Modification AE 4144 FM from FM only into AM/FM

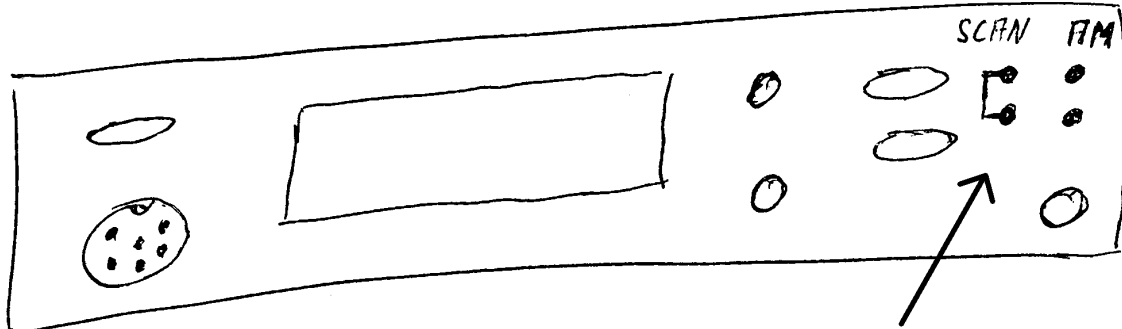
Disconnect power supply and open cabinet upper and lower parts.

On the front panel PCB You will find jumpers just besides the switches.
There is a jumper named "SCAN", which is inserted in the FM only version.

Please open this jumper and solder a new jumper into the holes named "AM"
